Capital District
Transportation Committee

Proposed Revisions to the Draft New Visions Plan Based on Comments Received

Bicycle & Pedestrian Priority Network: Replace page 26 with the following (changes are in red):

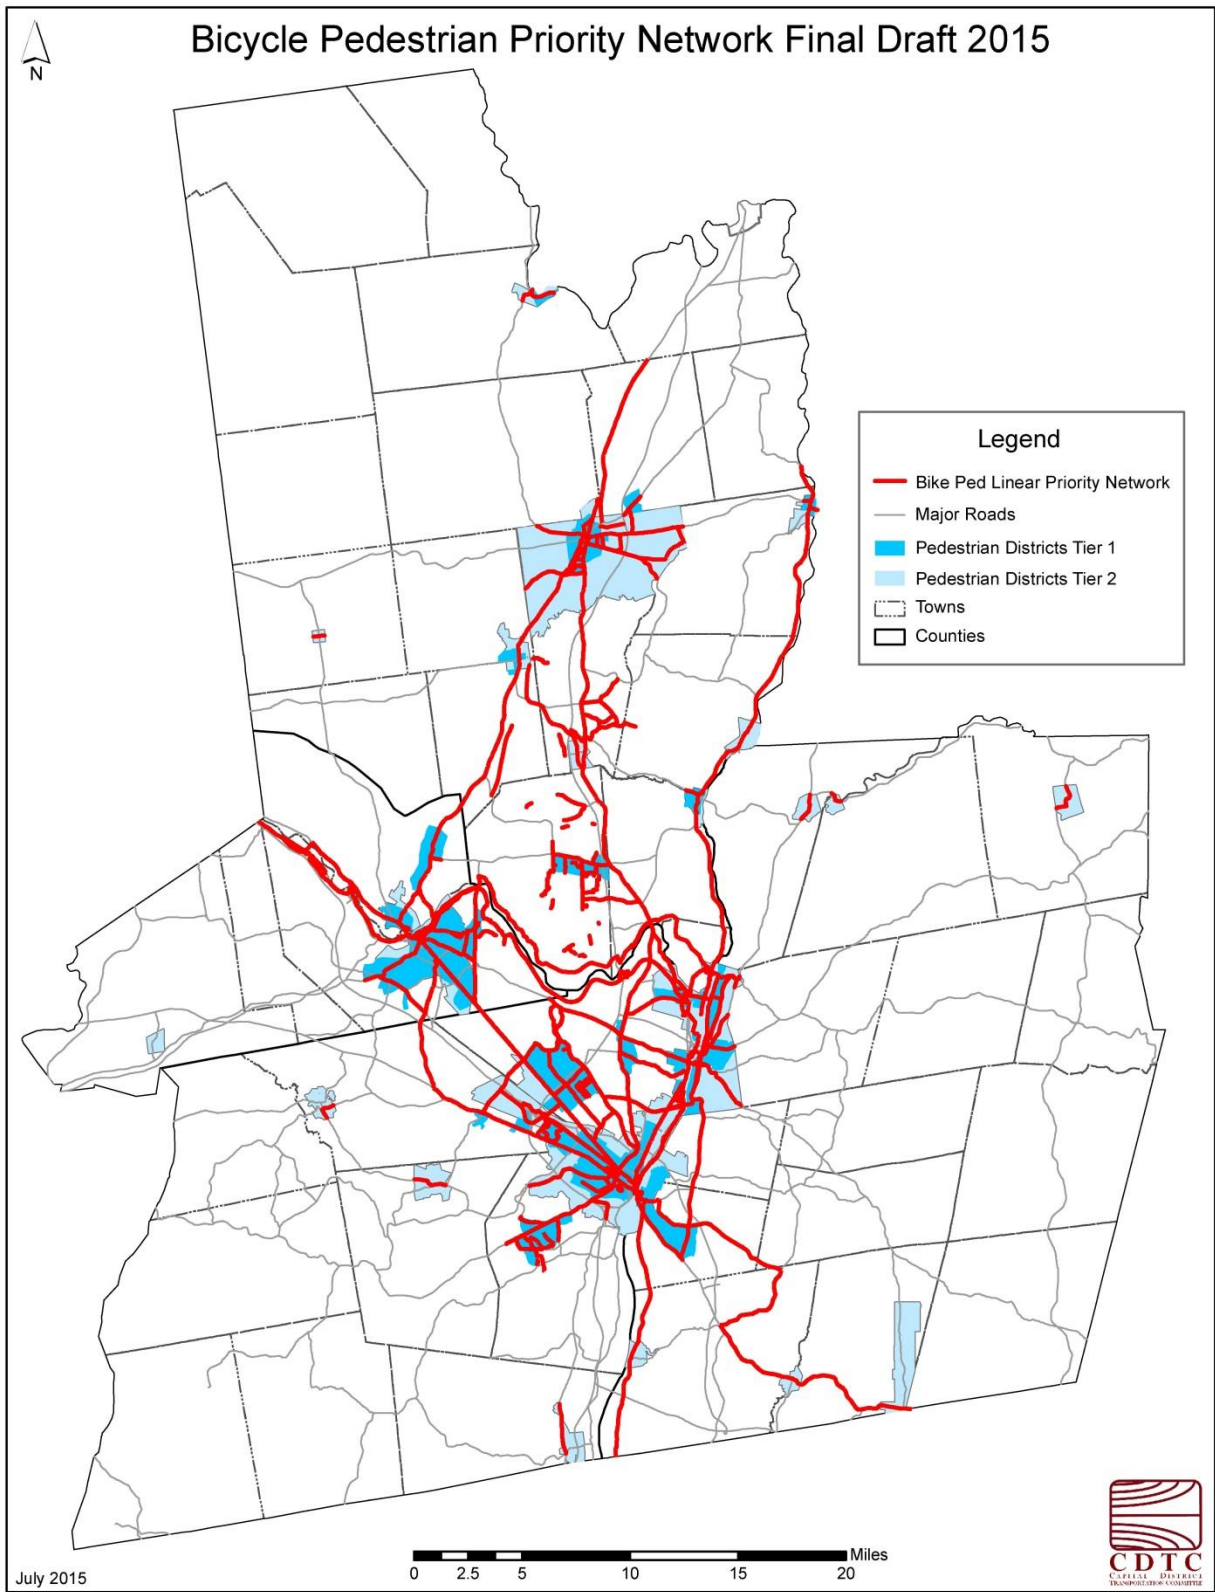
The new Priority Network will consist of two components— pedestrian districts and a linear bicycle network. The network has evolved to acknowledge that bicyclists and pedestrians have different needs and what improves safety for pedestrians doesn't necessarily improve safety for bicyclists and vice versa. To develop the Pedestrian Districts, CDTC staff, under advisement of the BPAC, began by mapping fixed route transit, low-income individuals, zero vehicle households, residents 65 years of age or older, residents 65 years of age or older living below the poverty level, and residents reporting a disability. These were mapped to illustrate and identify locations where the most need for safe pedestrian infrastructure exists. Areas of population and employment density were also mapped. For the most part, the identified populations overlapped areas of population and employment density. The next steps incorporated environmental justice populations which identify areas of low-income and/or minority populations, and destinations that generate pedestrian activity which include shopping centers, schools, trails, hospitals and parks. Intersection density, as defined above, and which corresponds to street connectivity, was also mapped.
